ADDENDUM NUMBER 02

PROJECT: CHEWACLA STATE PARK CAMPGROUND LOOP 1 ADA RENOVATION

PROJECT NUMBER: **ASPD PROJECT #: 2026-029-1711**

CONTRACTOR QUESTIONS/RFI's

Alabama State Parks Interactive Map

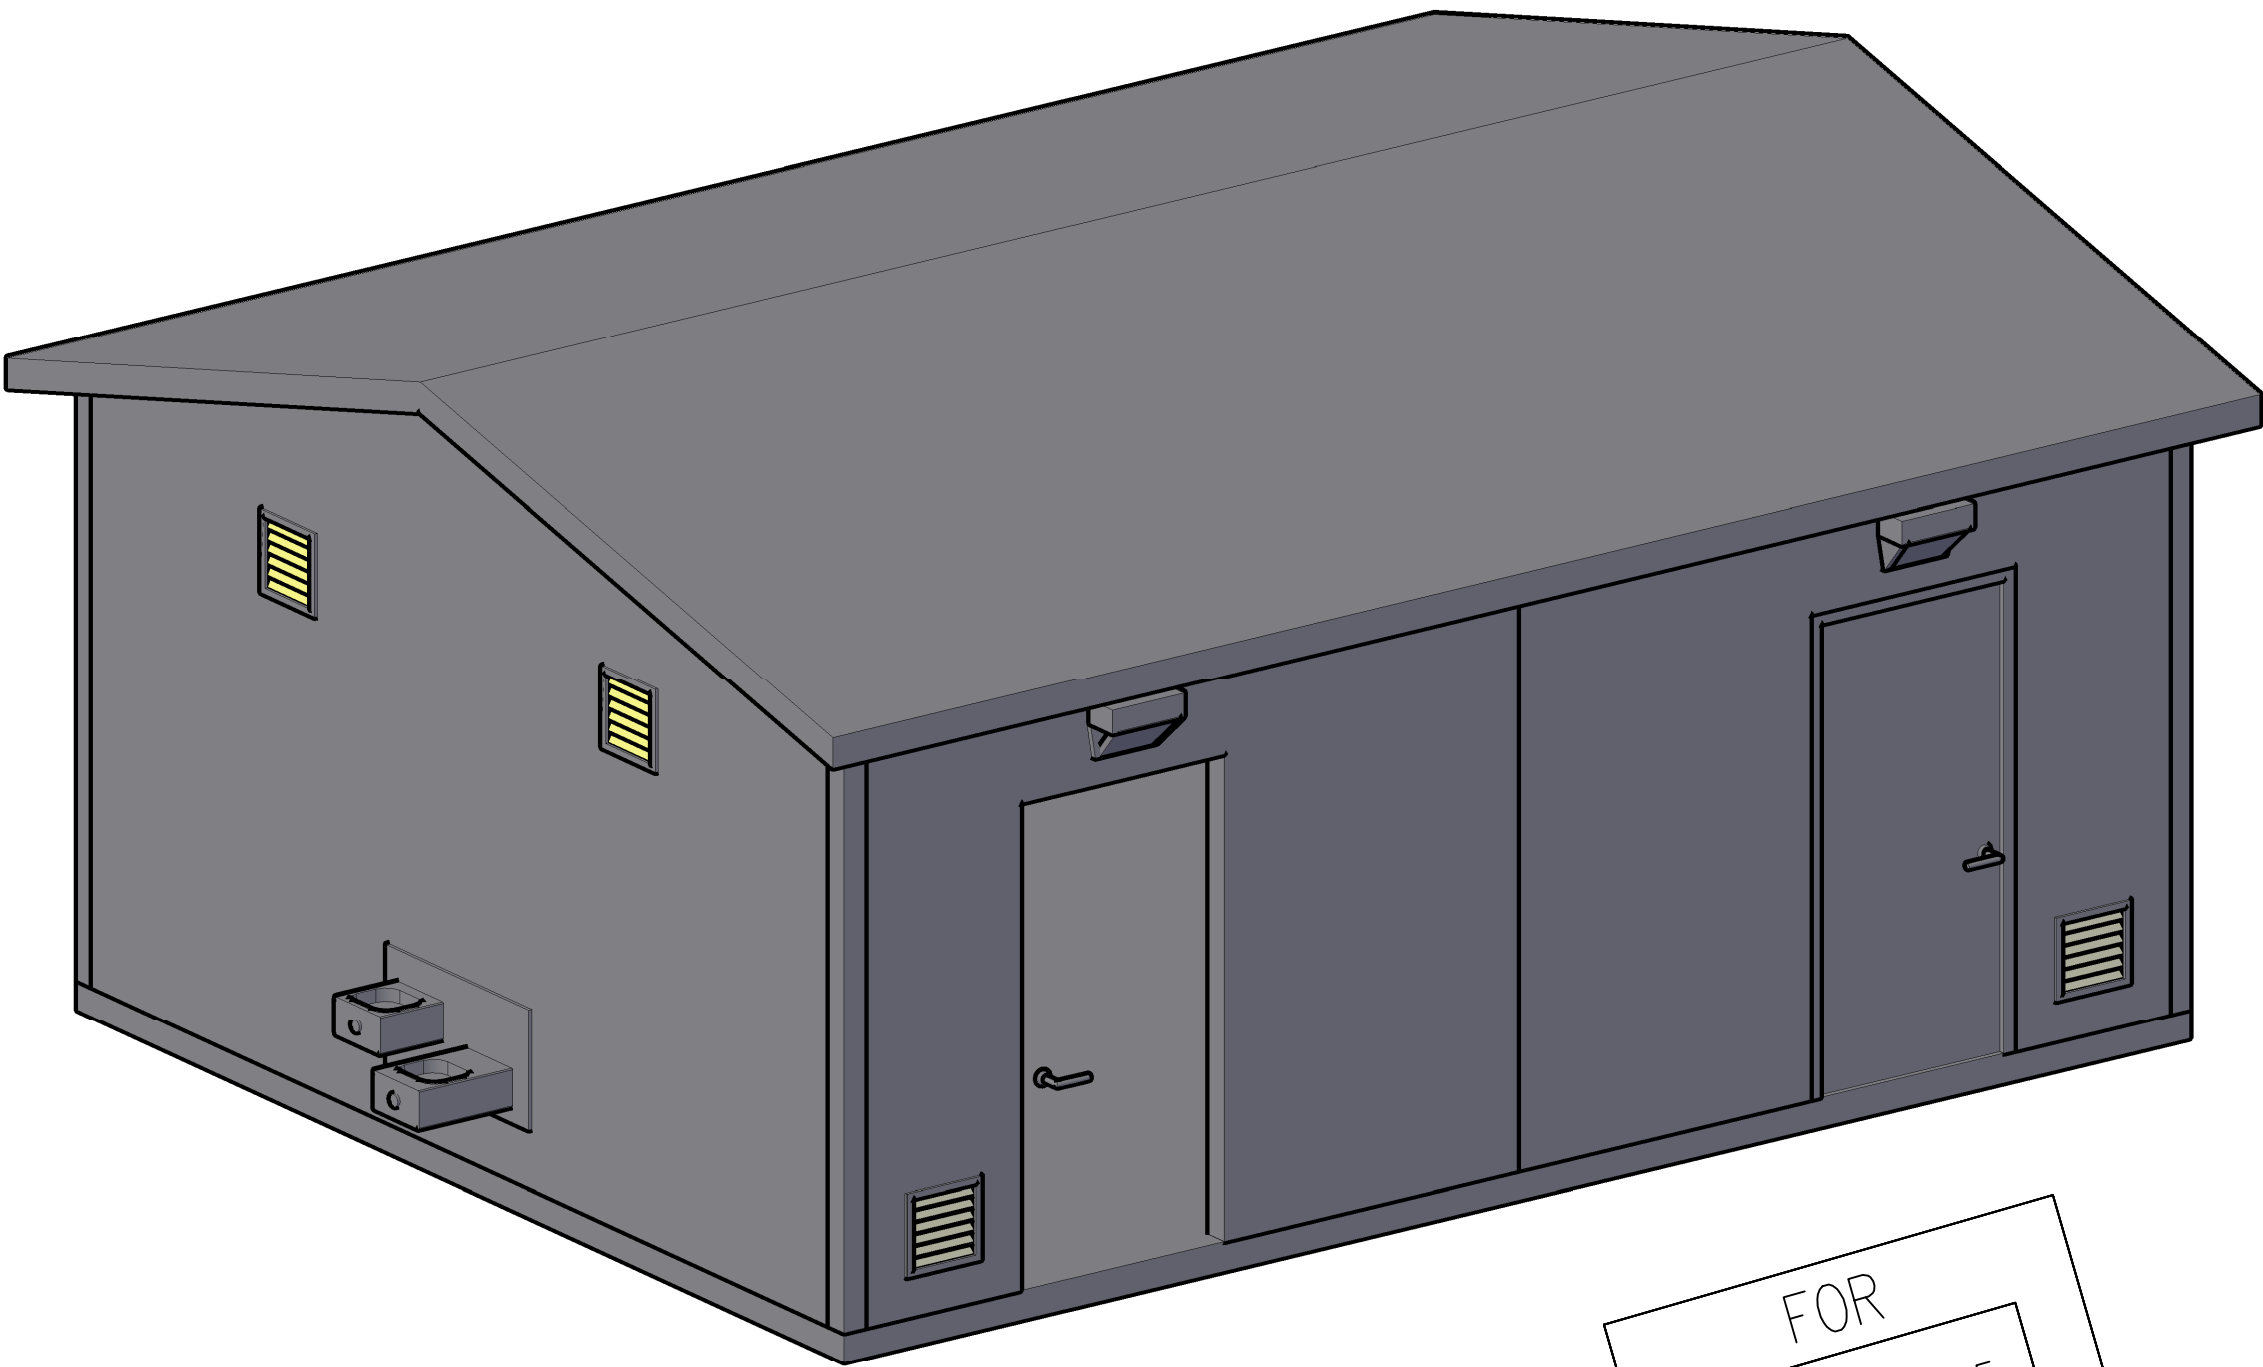
1. Service. SOW item 3 says to replace the electrical line from the transformer to the new building. Where is the transformer, and is it owned by Alabama Power or by the park? What is the approximate distance to the new bath house pad? Is the service 120/240V Single-phase? **See attached aerial showing location of transformer/pole that feeds the SOW of this project. The transformer is owned by Alabama Power. Everything from the transformer to the bath house is owned by the park. Contractor responsible for locating the power lines and distance to the bath house. Power line is SINGLE Phase, 240 volt. Panel inside bath house is 400 amp. Panel in new bath house will be 200 amp. Existing power line feeding the bath house shall be reused if serviceable. No splicing allowed for new bath house. Contractor must notify the Construction Manager if the existing power line is found to be unserviceable and need replacement.**

Yellow arrow shows location of power pole/panel that supplies power to campsites 1-8 and bath house.

Red arrows shows route power line takes to the existing bath house. Line comes into the building on the southwest corner. Power lines that feed the pedestals in the glamping area come out of the panel inside the building and run south. Exact routing is not known.

1 PLUMBING LAYOUT PLAN
E-11

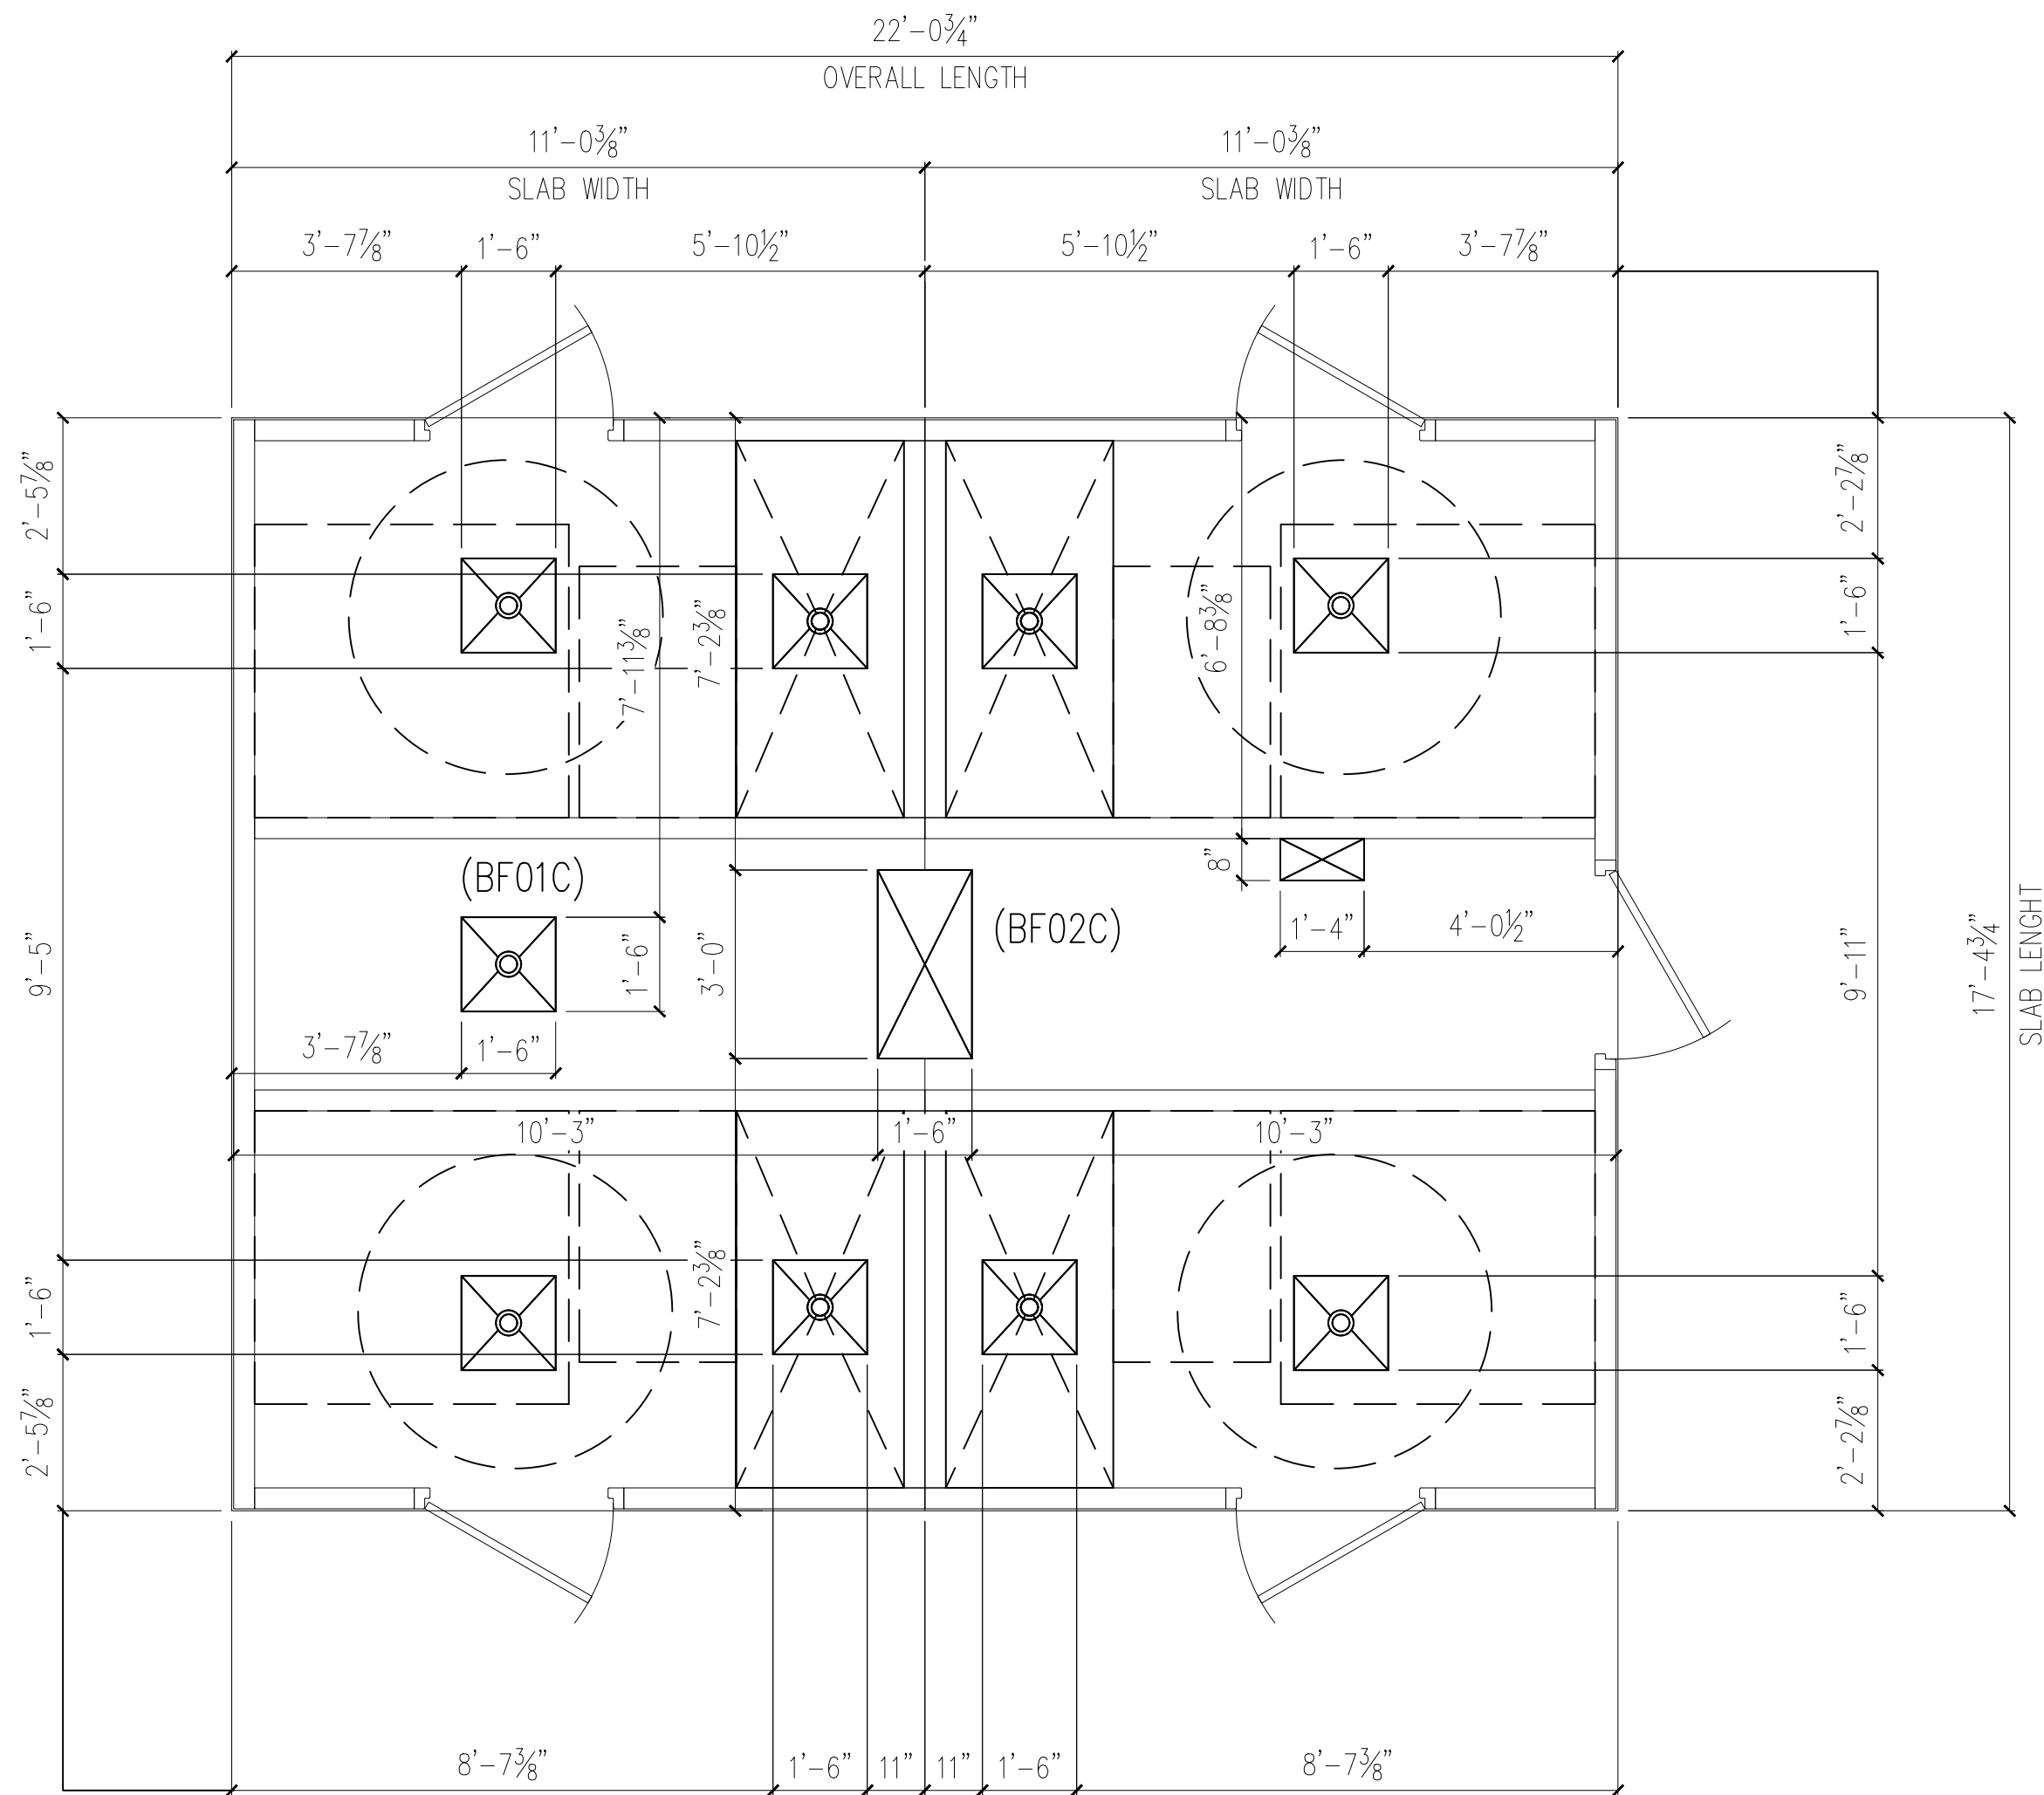
2. Precast restroom. Does the Smith-Midland / Easi-Set restroom arrive with its panelboard, interior lighting, receptacles and hand-dryer

wiring installed? Where is the service entry point on the unit? Everything is installed in the building. The contractor is responsible for connecting the water, sewer and power to the building. Smith-Midland representative will check these connections for leaks and continuity before leaving the park. Service connections enter the building through the block outs in the floor. See submittal attached.
